BMW Motorrad USA

Service Information Bulletin

****Technical Campaign****

Subject: Retrofitting Timing Chain Guide

chain guide installed (1)

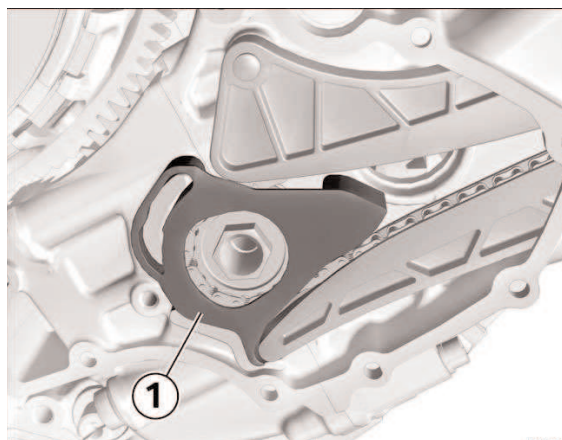
Details: BMW Motorrad has ascertained that on engines that have reached high mileage, the timing chain can stretch due to normal wear. In isolated cases, this can result in the timing chain slipping over the crankshaft gear before hydraulic pressure can build up in the chain tensioner when the engine is being started. The outcome can be damage to the valve train.

Aftersales Solution: When a motorcycle affected by this Technical Campaign is brought in for its next BMW service, it is to be checked, and if needed, the chain guide is to be retrofitted. See work item 11 11 515 on the latest RSD (Repair and Service Data BMW Motorrad) DVD for a description of the procedure for installing the chain guide.
